# Agenda

## Planning Decisions Committee

6.30pm, Wednesday 14 July 2021

1. This report provides the Planning Decision Committee (PDC) with an assessment of planning permit application PLN20/0869 against the provisions of the Yarra Planning Scheme (the Scheme) and recommends that Council notify the Victorian Civil and Administrative Tribunal (VCAT) and all parties to the proceeding that Council supports the application, subject to conditions contained within the officer recommendation.

**Figure 41 – Part S-E elevation of proposed development (left) and N-W elevation of development approved under PLN17/0705 (right) indicating FFL of corresponding Level 3 above natural ground level (notations added by planning officer)**

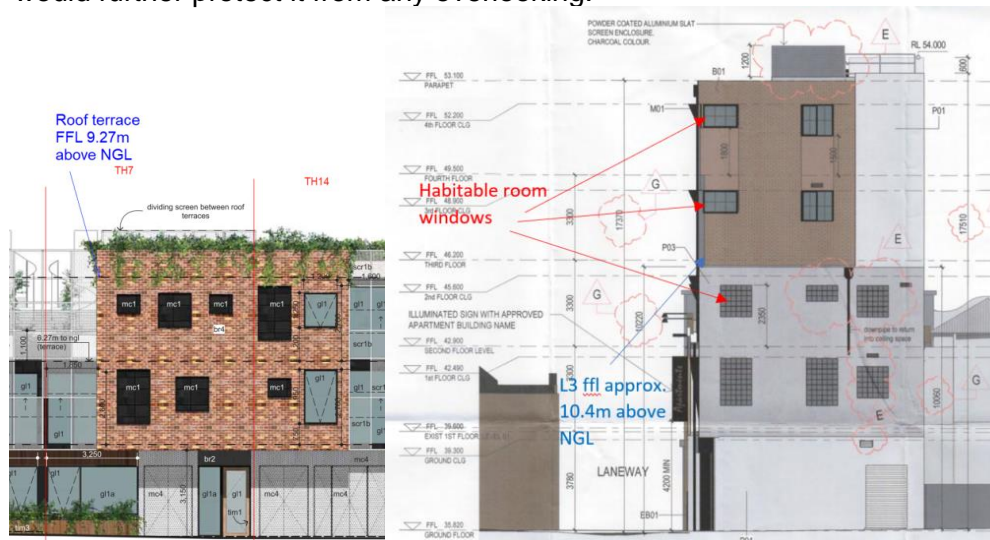
342. It is also noted that the approved development at No. 388-390 Queens Parade under planning permit PLN17/0705 has a number of habitable room (bedroom) windows facing the subject site (north-west facing) at the second to fourth floor – see right hand side of figure 41. However, it is considered that, in the event that both developments were constructed, no unreasonable overlooking would occur for the following reasons:

- (b) At third and fourth floor, the bedroom windows are clear glazed, with a sill height of 1.8m above finished floor level, have a shallow (maximum 0.4m deep) shroud and are set back 3m from the north-west boundary. These windows would not be overlooked by development at No. 390A Queens Parade due to the more generous floor to ceiling levels associated with the development at No. 388-390 Queens Parade (as per endorsed plans for PLN17/0705), indicating that the finished floor to Level 3 roof terraces at No. 390A Queens Parade would be lower than the corresponding level 3 finished floor level of development at No. 388-390 Queens Parade – see figure 41 comparing both developments. In addition the 1.8m sill height of the bedroom window would further protect it from any overlooking.

os12 - overlooking study - th6 & 386 queens pde  
scale 1 : 50

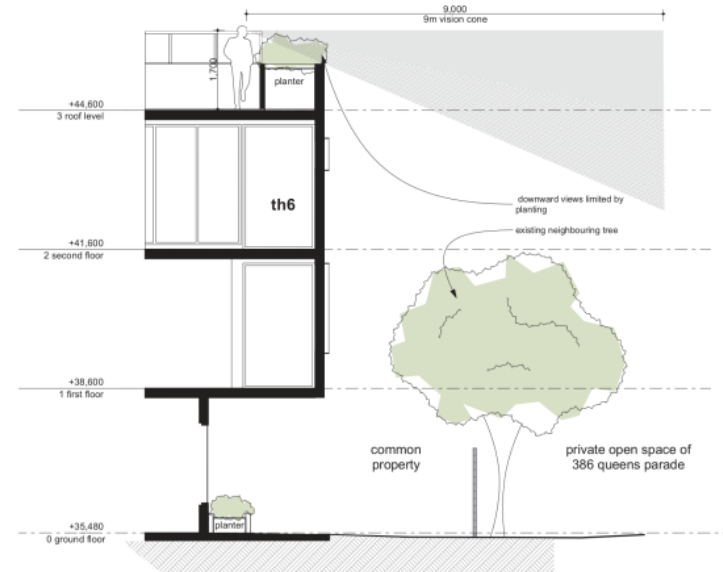
- (c) At level 3, the overlooking sectional diagram (OS12 on drawing TP13C) clearly demonstrates that the intervening planter box associated with the terrace will prevent downward views to the rear private open space of No. 386 Queens Parade.
